**RE: Hampton Inn (Holly Ave)  
Grading Plan and Drainage Report  
Engineer's Stamp Date – 4-22-2016  
Hydrology File: C18D073B**

DRB Project Number: 1010357  
Holly Hampton Inn

DRB Project Number: 1010357 Hearing Date: 4/20/2016  
Project: Hampton Hotel Agenda Item No: 3

ENGINEER'S SEAL  4/22/16 DAVID SOULE P.E. #14522	HOLLY HAMPTON INN  GRADING AND DRAINAGE PLAN  1806 CENTRAL AVENUE SE SUITE 201 ALBUQUERQUE, NM 87106 (505) 872-0999	DRAWN BY WCWJ DATE 4-21-16 21423-LAYOUT-12-05-14 SHEET # JOB # 21423

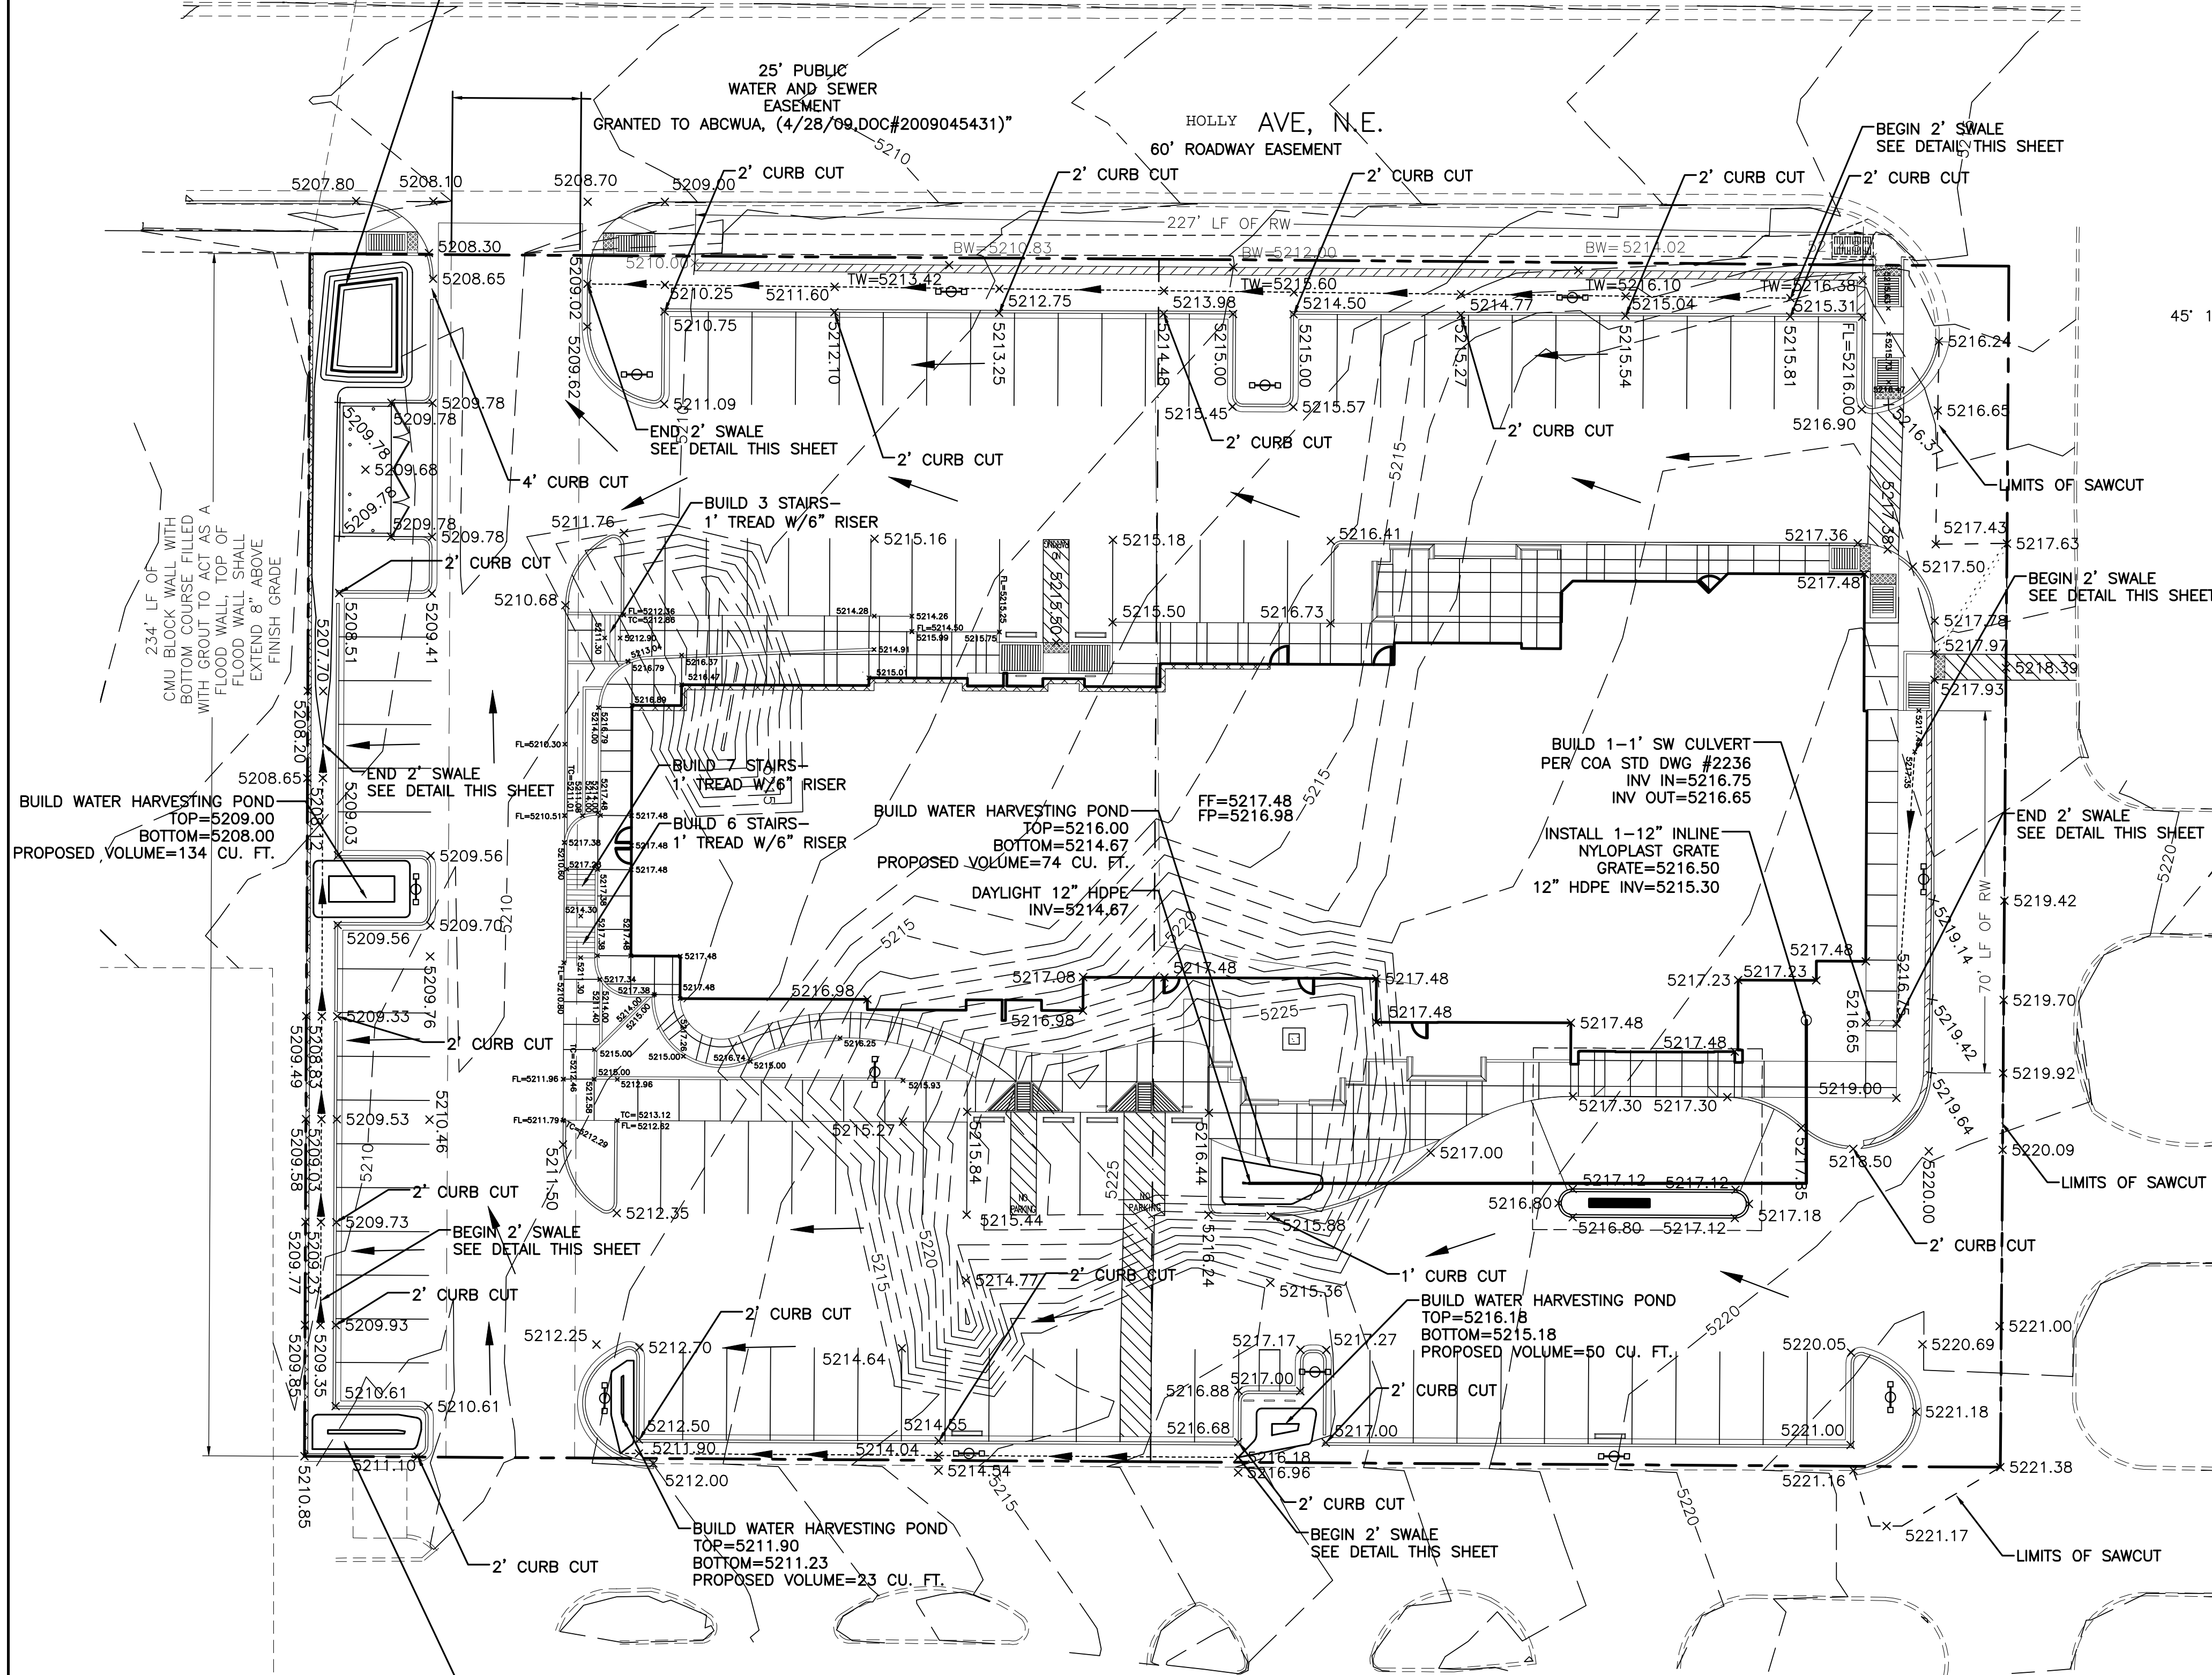
- Hydrology has an approved grading plan, and drainage report (stamp date 11-18-15), for Site Plan approval.
- The drainage report states that this site receives unland flows. A private cross lot drainage easement may be needed. **We are adding blanket cross lot drainage**
- Tract A was to discharge thru a shared access drive along the eastern edge, but it appears from the grading that it now discharges thru this site. Provide supplement to drainage report showing how much flow will be entering from Tract A, and how it will discharge. **Flows are accepted. passed thru north drive isle onto holly**
- Lots 21 and B1 both discharge thru this site. Was swale was sized to accommodate these flows? Report needs supplement information addressing offsite flows.

**We have added channel section calculations**

NEW TEMPORARY ASPHALT CHANNEL (SEE DETAIL BELOW)

1. ALL SPOT ELEVATIONS REPRESENT FLOWLINE ELEVATION UNLESS OTHERWISE NOTED.
2. ALL CURB AND GUTTER TO 6" HEADER UNLESS OTHERWISE NOTED.
3. ALL RETAINING WALL DESIGN SHALL BE BY OTHERS.
4. A BLANKET CROSS LOT DRAINAGE EASEMENT SHALL BE GRANTED TO TRACT A AND B-1 HOLLY PLACE AND LOT 21 BLOCK 18 TRACT A, UNIT B NORTH ALBUQUERQUE ACRES.
